April 3, 2024

IDEA Public Schools Upper RGV Mechanical Upgrades CSP#23-URMU-0424

ADDENDUM NO. 2

IDEA EDINBURG BUILDING B MECHANICAL & ELECTRICAL ROOF PLAN

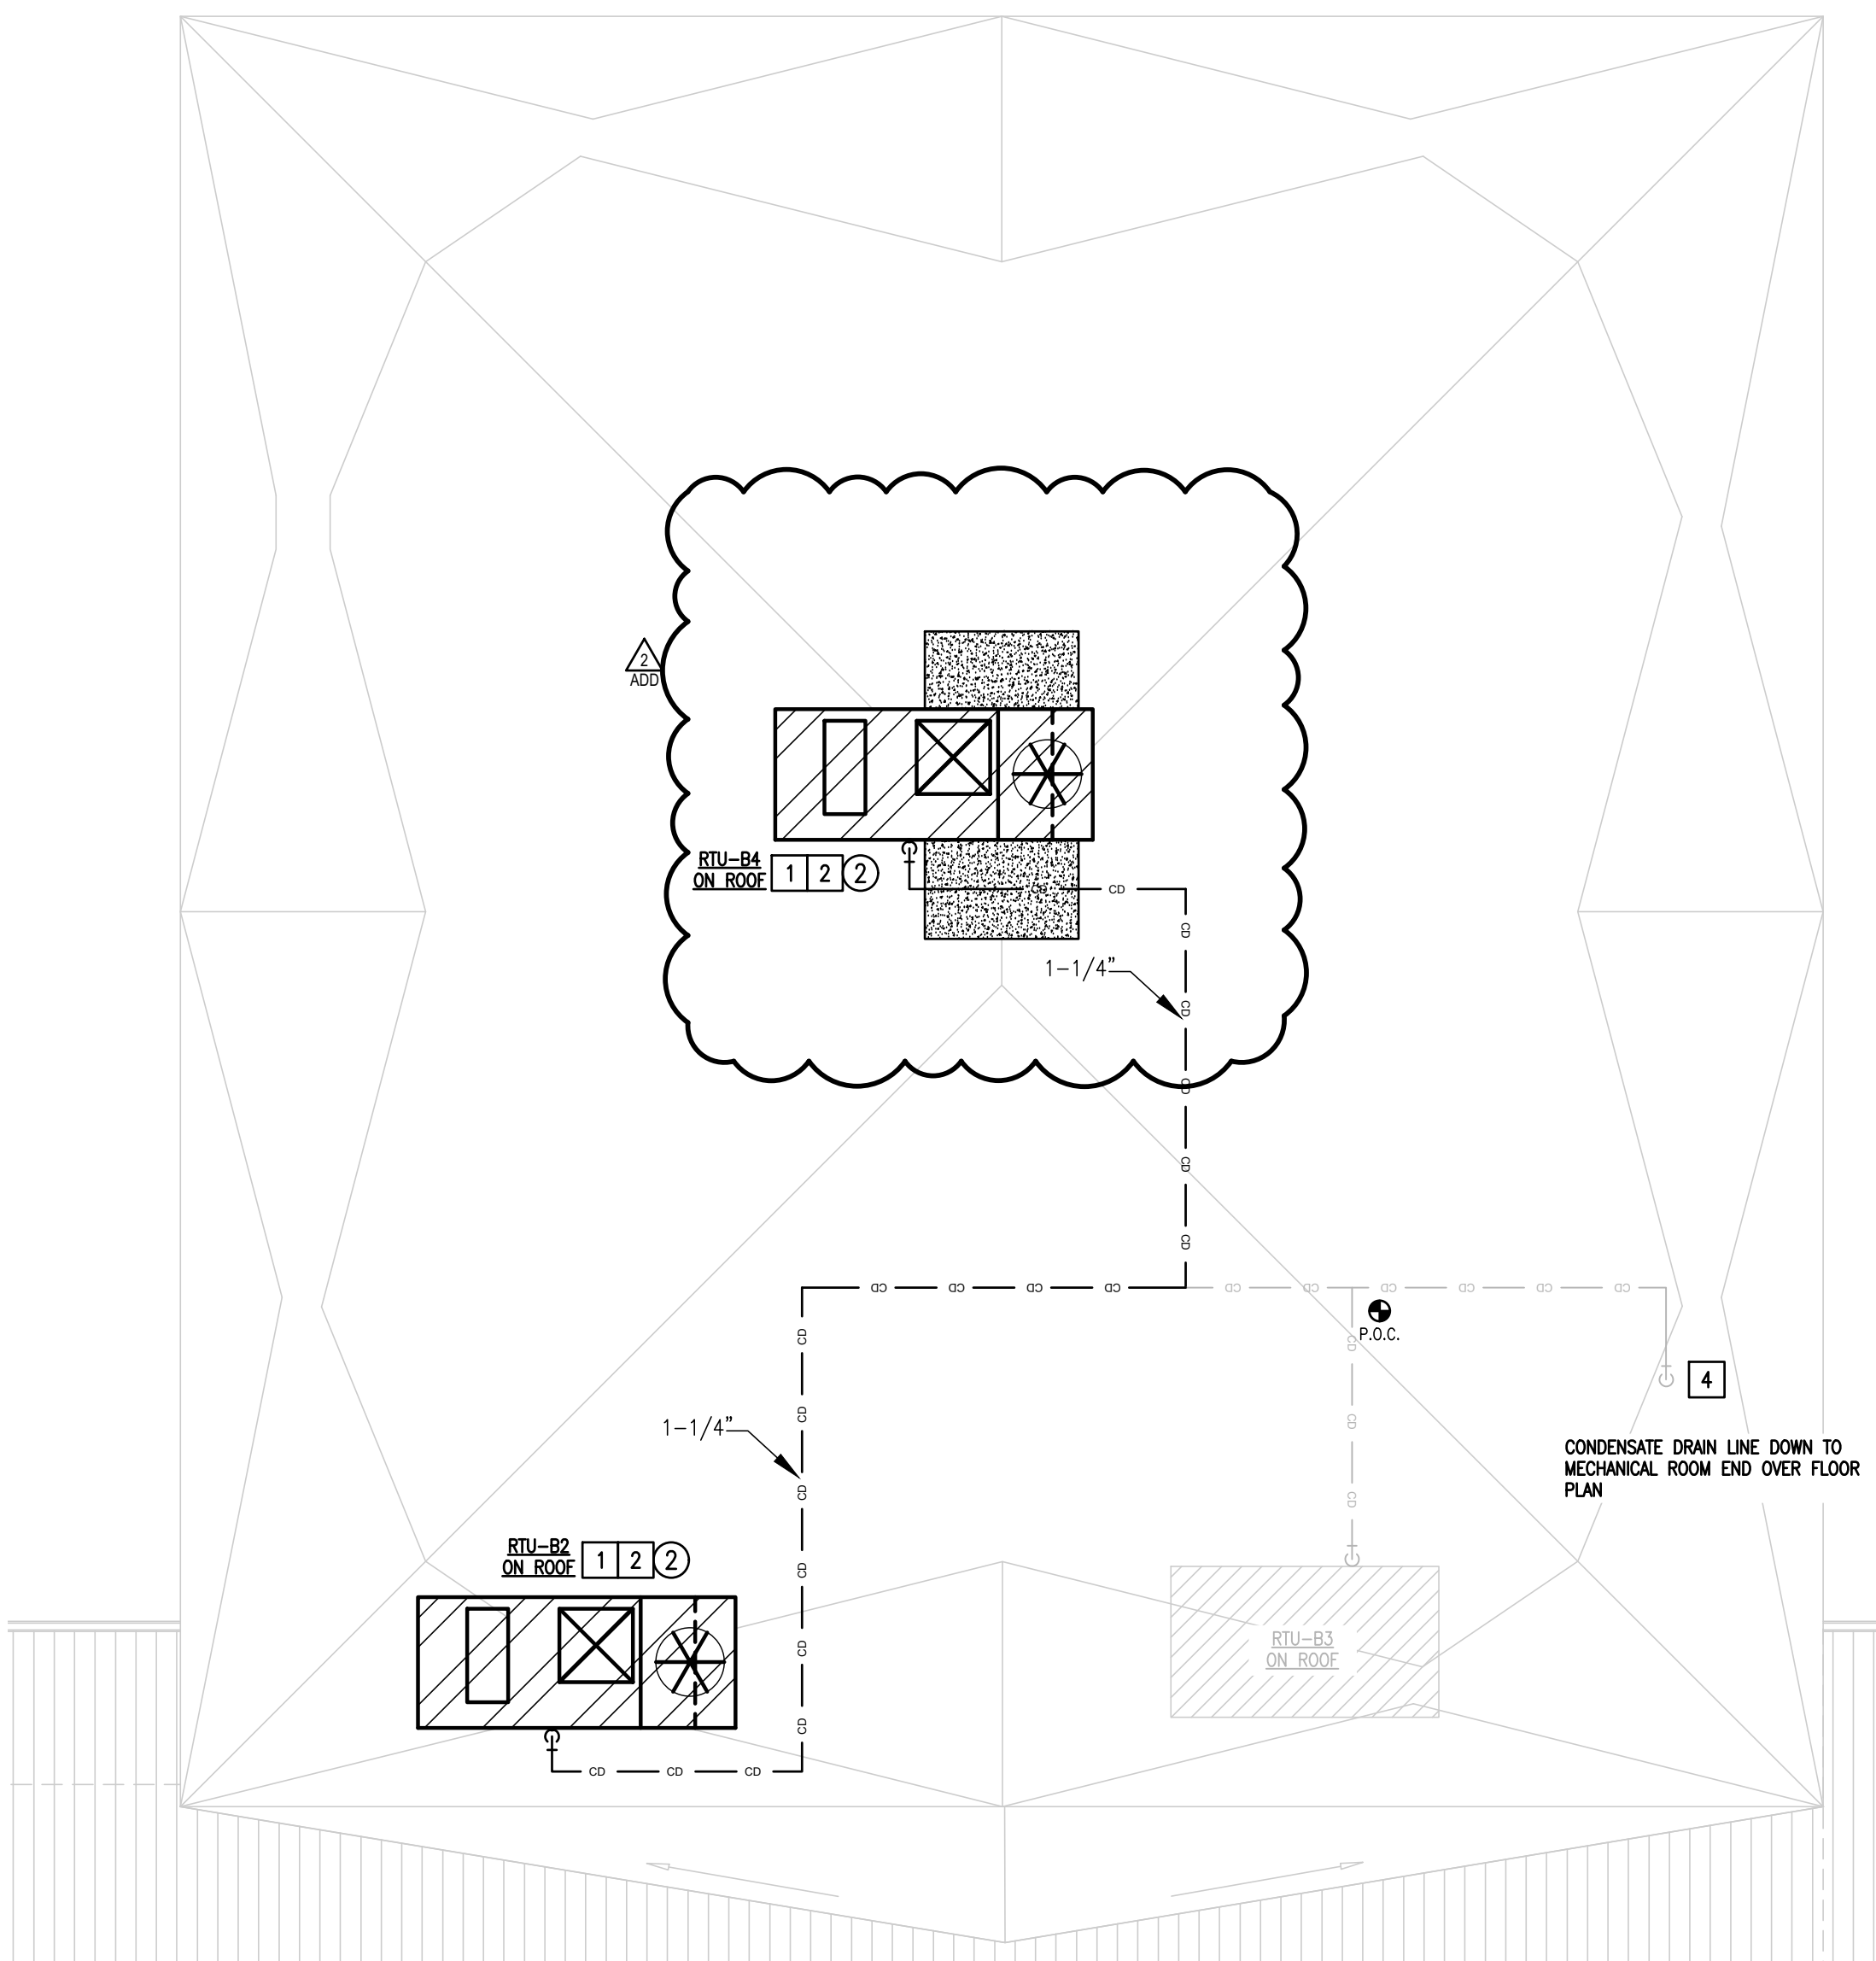
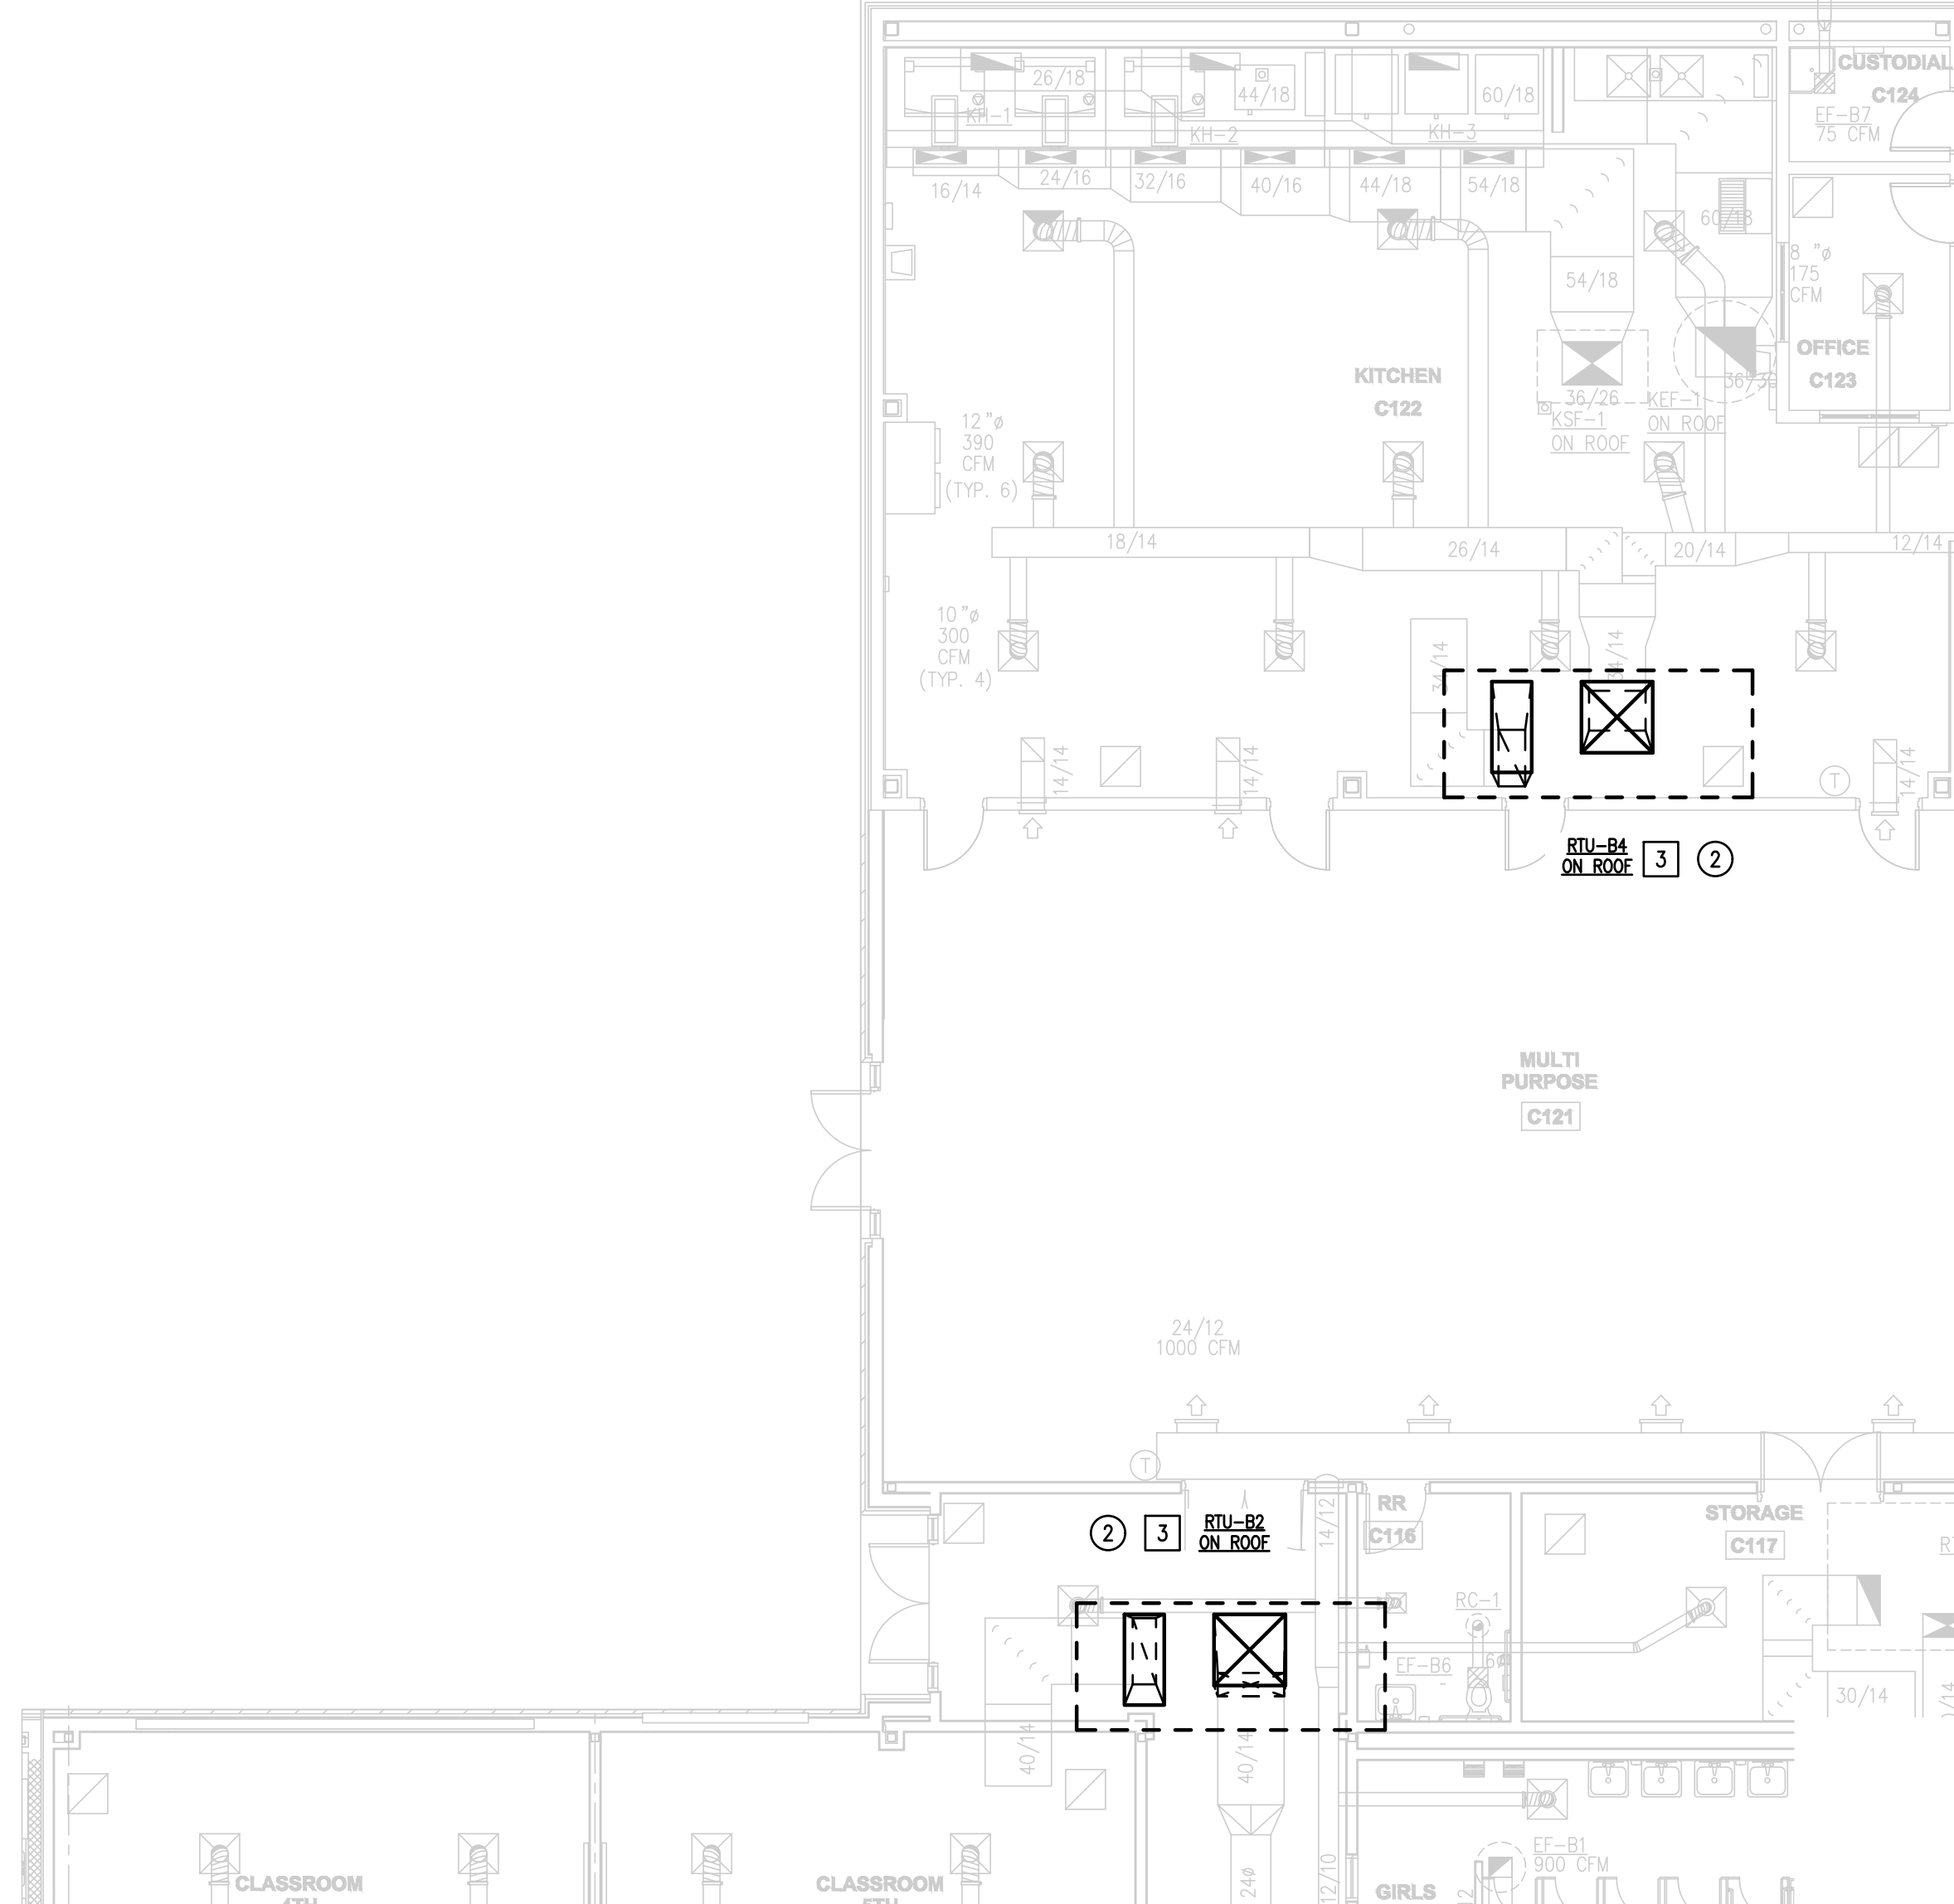
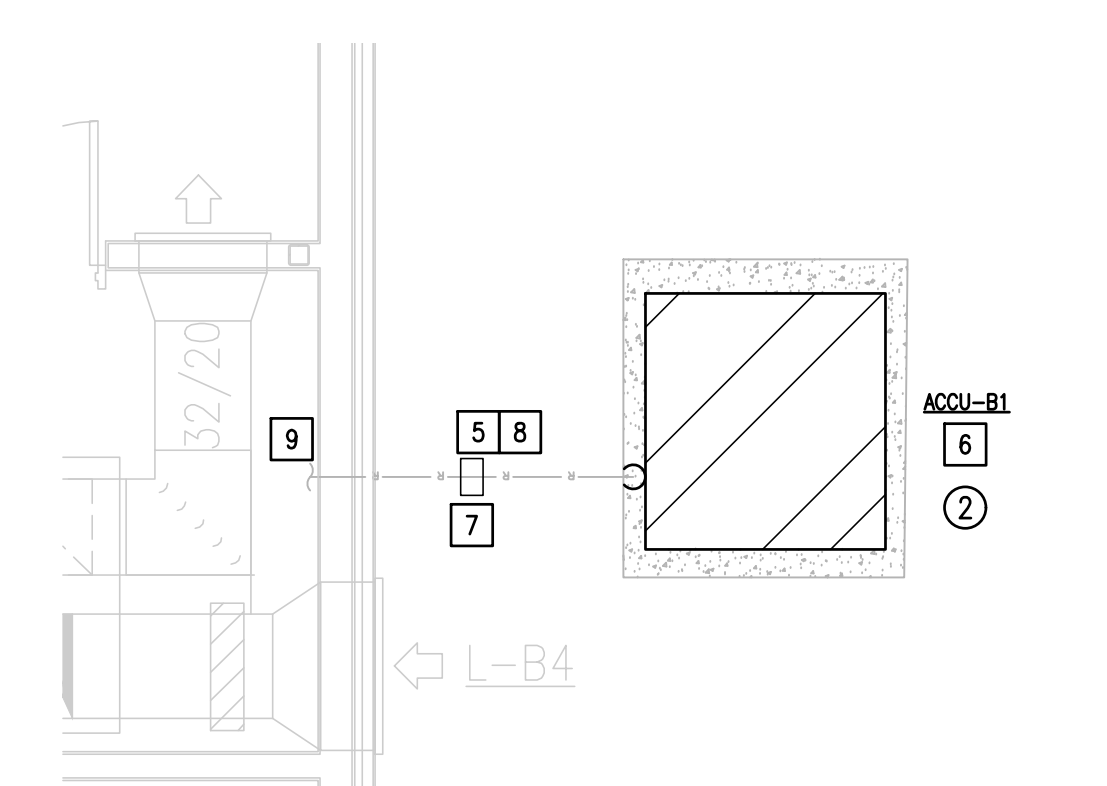
6. Sheet ME-3.4 – See attached.
 - a) Added Base Bid identification to schedules.
 - b) Updated keyplan.
7. Sheet ME-4.1 – See attached.
 - a) Added Base Bid identification to schedules.

- b) Roof patch work shown for RTU-B4.
8. Sheet ME-4.2 – See attached.
 - a) Added Base Bid identification to schedules.
9. Sheet ME-5.1 – See attached.
 - a) Added Base Bid identification to schedules.
